# PMD Control Timing

# P802.3bj Draft 2.1 Comment #94

# Comment #94 as Implemented in P802.3bj Draft 2.2

## 92.7.12 PMD control function

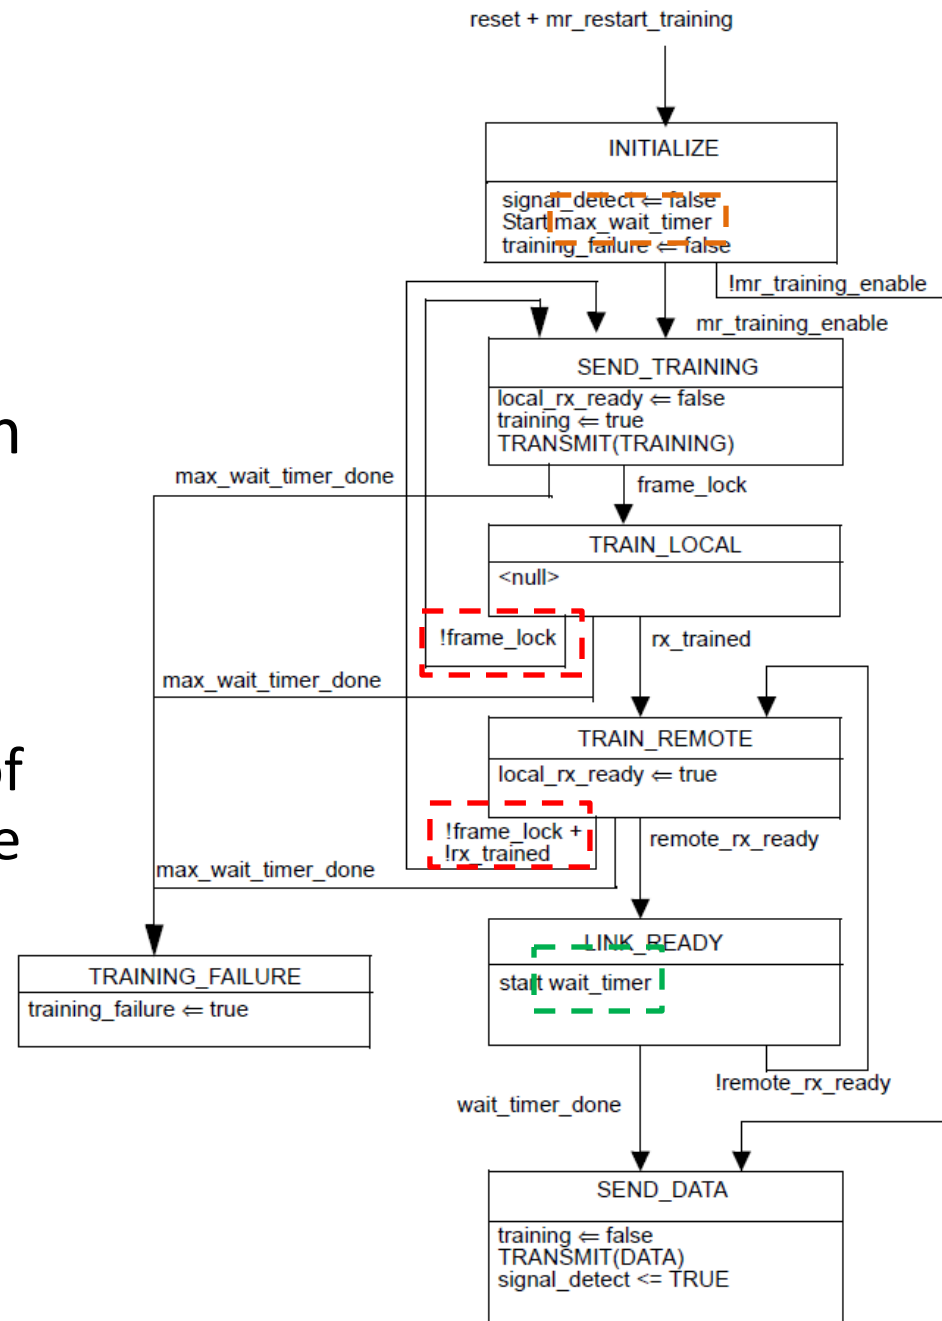
The response time requirement is dependent on the status of frame\_lock\_i which may be difficult to verify (e.g. if the MDIO interface is unavailable) and synchronize with a captured waveform. In addition, it is not available to the link partner.

It is relatively easy to make the lane frame lock state available as part of the status report field. This information would be very useful in analyzing link training issues and thus promote interoperability.

In clauses 92 and 93, assign cell 14 of the status report field (currently reserved) to represent the value of the PMD status variable frame\_lock\_i.

In clause 94, use cell 7 of the status report field instead of cell 14 (14 is already assigned, 7 is currently reserved).

- Is the 2 msec response to a coef update from a partner enough time?
  - i.e. if the local RX somehow loses frame\_lock in TRAIN\_LOCAL or TRAIN\_REMOTE states?
- Is it necessary to bound the time from the start of the training process to the first coef update request response?
  - There is no limit today.

- In D2.2, what happens if the 2 ms response is not possible due to something?
  - i.e. Remote TX is broken in a way that a response is not possible
- D2.2 has the 2 ms response as normative with PICS statement
- What should the spec require to fix it?
- Possible solutions:
  - ~~Do nothing (don't change the spec in any way)~~
  - ~~Remove 2 ms normative requirement~~
  - Revert to draft 2.1 text
    - Does not prevent parts from being compliant
    - No easy way to verify response time against the normative specification
  - Revert to draft 2.1 text but add frame\_lock indication in the control channel
    - Original comment #94
  - ~~Create a bailout mechanism for the aforementioned case~~
- Consensus to revert to draft 2.1 text

After initial frame lock the the response time should be 2 ms regardless of whether the receiver loses frame lock or not.

In addition to the coefficient update process specified in 72.6.10.2.5, after responding to the first request after training begins, the period from receiving a new request to responding to that request shall be less than 2 ms.

In addition to the coefficient update process specified in 72.6.10.2.5, after responding to the first request after training begins, the period from receiving a new request to responding to that request shall be less than 2 ms. The start of the period is the frame marker of the training frame with the new request and the end of the period is the frame marker of the training frame with the corresponding response. A new request occurs when the coefficient update field is different from the coefficient field in the preceding frame. The response occurs when the coefficient status report field is updated to indicated that the corresponding action is complete.
